Sydney North Planning Panel

SNPP No	2017SNH042
DA Number	MOD2017/85
Local Government Area	City of Ryde
Proposed Development	Modification to LDA 2015/0654 pursuant to S.96(2) including various changes to the car parking area, modifications to floor plans on all levels, reduce the communal open space area on the roof top and provide private roof top terraces.
Street Address	723-731 Victoria Road, 10 Little Church Street & 3-7 St Annes Street, Ryde.
Applicant	CD Architects
Number of Submissions	Nil
Regional Development Criteria (Schedule 4A of the Act)	Original Consent determined by Sydney East Joint Regional Planning Panel as the Capital Investment Value Exceeded \$20M.
List of All Relevant s79C(1)(a) Matters	<ul style="list-style-type: none"> • Environmental Planning and Assessment Act 1979; • State Environmental Planning Policy (Building Sustainability Index: BASIX); • State Environmental Planning Policy No 65 – Design Quality of Residential Apartment Development; • Ryde Local Environmental Plan 2014; and • City of Ryde Development Control Plan 2014. • S94 Contribution Policy

Assessment Report and Recommendation

Figure 9: Proposed increase to the building. Green outline is the approved building outline. The proposed extension is within the lower ground void area therefore no visual impact.

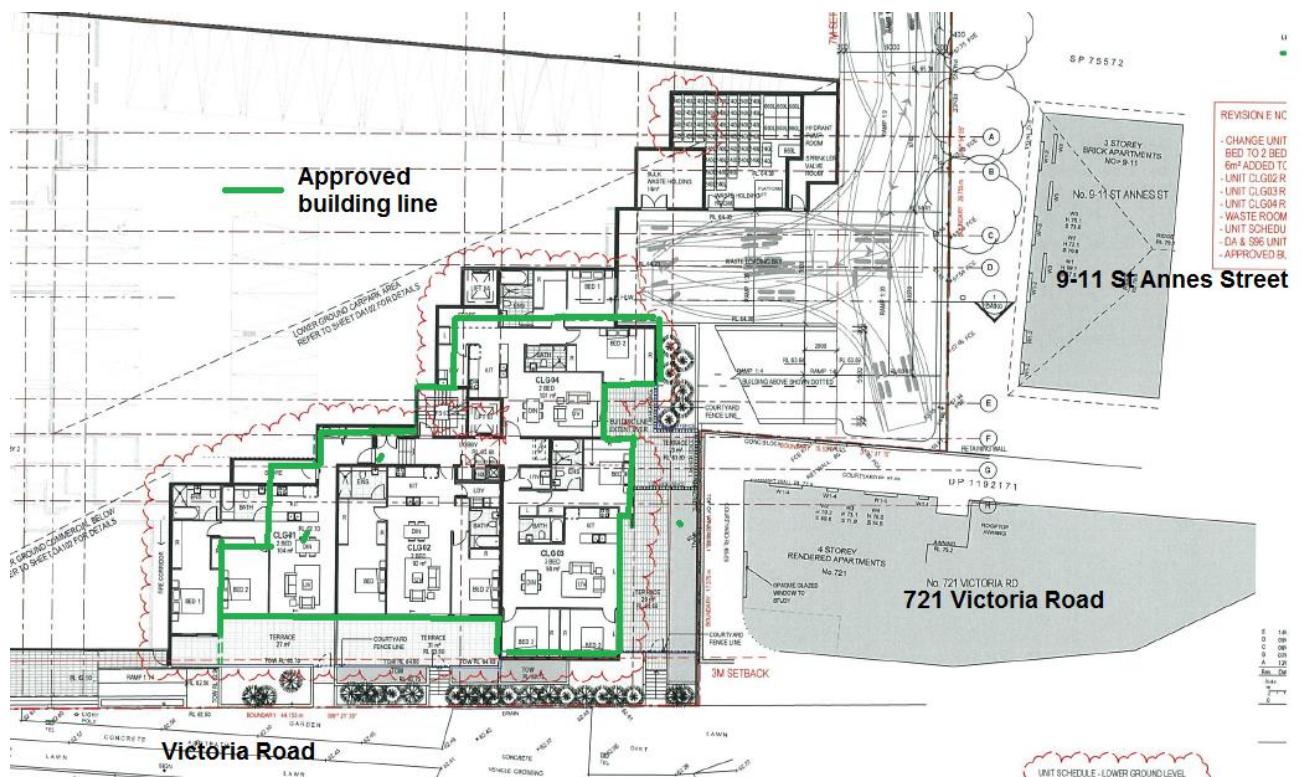
It is proposed to enlarge the residential component by extending the units to the northern and western elevation, (adding 85m² of floor area) as illustrated below. The additional area will not be viewed from any public domain as the extension is into a void area.

Figure 10: Ground floor with approved building outlined in green.

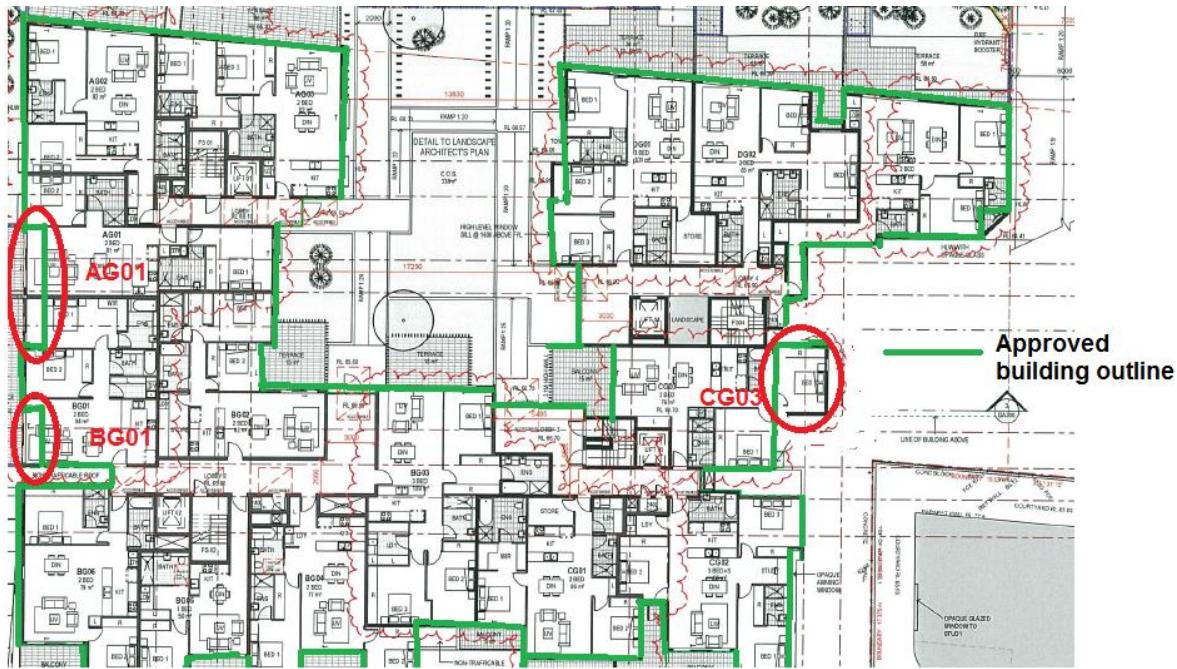
It is proposed to do internal work to rearrange the unit configuration and mix and to extend Units AG01 & BG02 to be in line with the western elevation. Unit CG03 will

also be enlarged (changed from a 1 bedroom to 2 bedroom) by extending the north eastern wall to provide an additional bedroom. See **Figure 10** below showing the approved building outlined in green and the proposed extension to Units AG01, BG01 & CG03. The proposed modifications are considered satisfactory and will not greatly alter the external appearance of the building with minimal adverse impact to any adjoining properties.

Figure 11: First and Second floor.

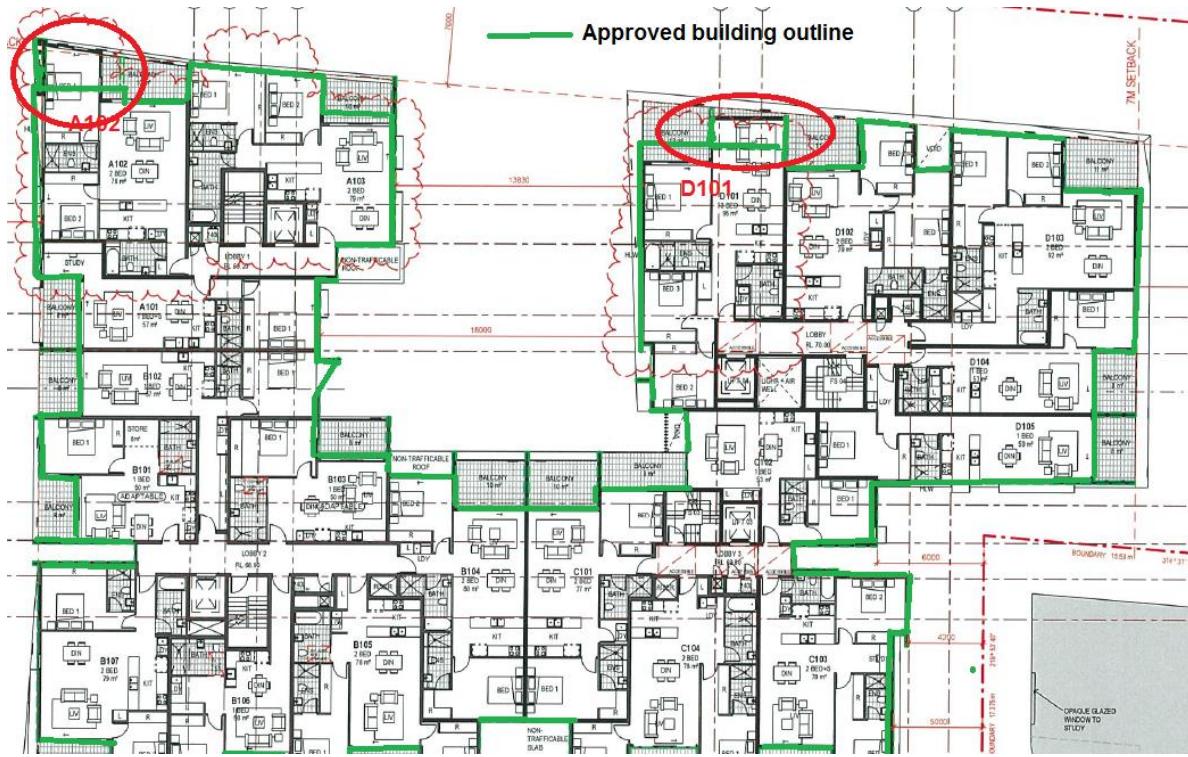
Internal changes to Units A102, A202 and D101 and extending their northern wall out to be in line with the approved building footprint. The extension will not extend beyond the approved building footprint and is not considered to have any adverse impact in terms of overlooking or overshadowing.

Figure 12: Level 3 with extension of B302 to provide an additional bedroom.

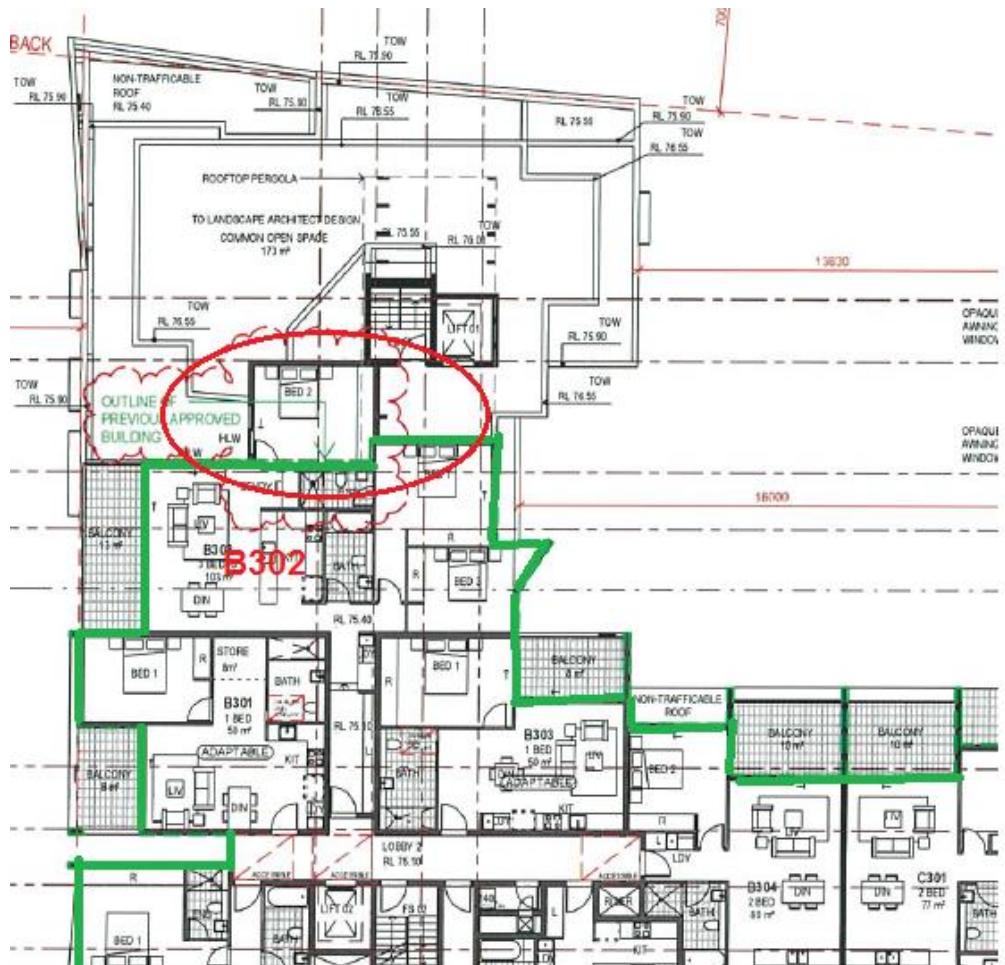
It is proposed to extend Unit B303 located on the rooftop of Building A. The proposed modification will change the approved two bedroom unit to a 3 bedroom unit. An additional bedroom is proposed as shown below. The additional bedroom will reduce the common open space on the roof area from $189m^2$ to $173m^2$. The reduction in open space by $16m^2$ is relatively minor and the proposal is still able to comply with the common open space provision of 25%. The proposed modification is considered satisfactory as there will be no adverse impact in terms of loss of amenity.

Figure 13: Levels 4 & 5 changes to Building D.

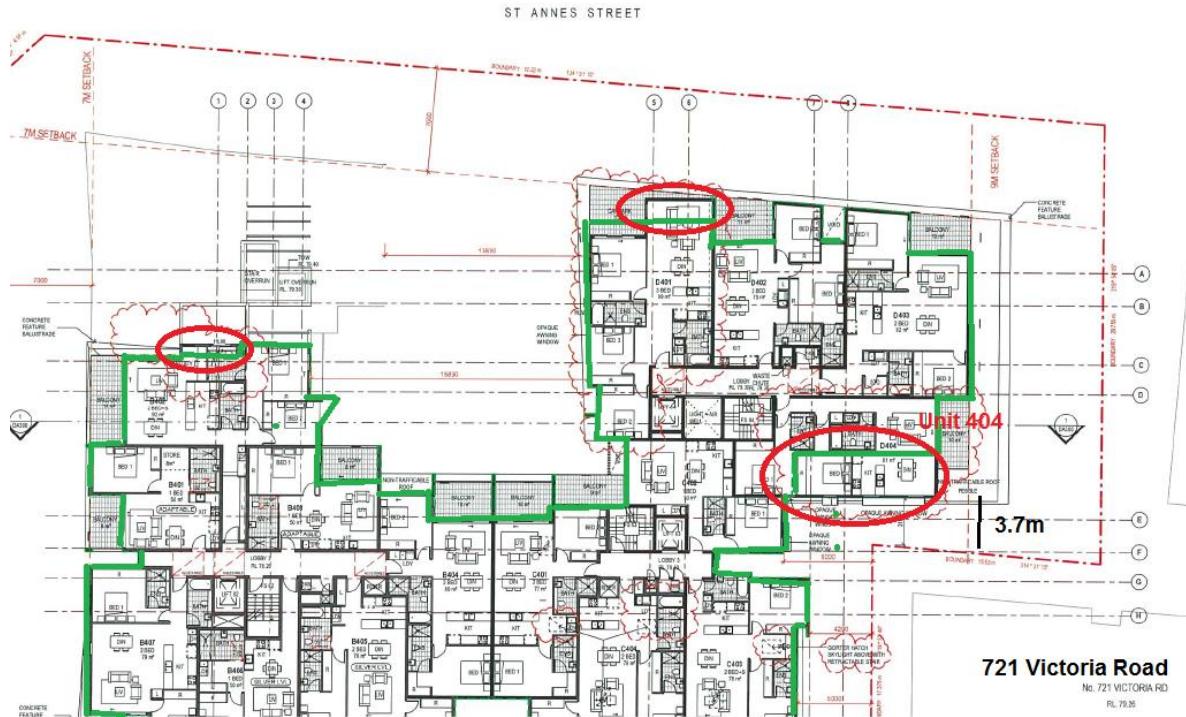
It is proposed to extend Units D402, D401 & D404 (and above) as illustrated below. The increase in the floor plate is relatively minor, with increase of 6m² floor space for Unit D402, 3m² for Unit D401 and 30m² for Unit D404 (changed from 1 bedroom to 2 bedrooms).

The modifications will not have any adverse impact in terms of overlooking or visual impact and can be supported. Whilst Unit D404 and D504 will now extend further south, it will now be in line with the units below resulting in a setback of 3.7m from the common boundary, in line with the rest of the building. The elevation with the reduced setback will have opaque awning windows to minimise any overlooking to the adjoining property. These opaque awning windows are frosted glass window with restricted opening, as illustrated on page 16 of the report. Given that it is for a relatively short elevation and that overlooking is minimised, no objections are raised to the proposed modifications.

Figure 14: Level 5 – changes to the roof area of Building C

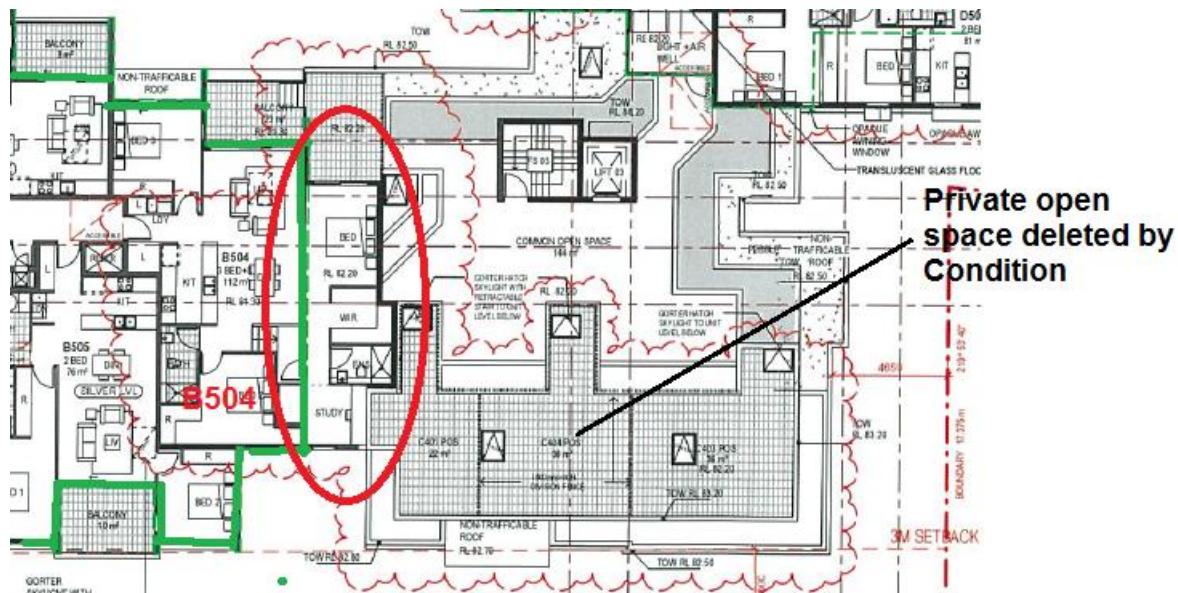
It is also proposed to extend Unit B504 to change it from a 2 bedroom unit of $80m^2$ to a 3 bedrooms + study of $112m^2$. The extension will be within the approved roof top common open space area of Building C. This area was approved with an open space of $190m^2$. It is now proposed to reduce this area by $22.4m^2$.

The overall reduction in communal open space is relatively minor, being total $38m^2$. The proposal will still provide the required communal open space (30%) which is more than required under the ADG.
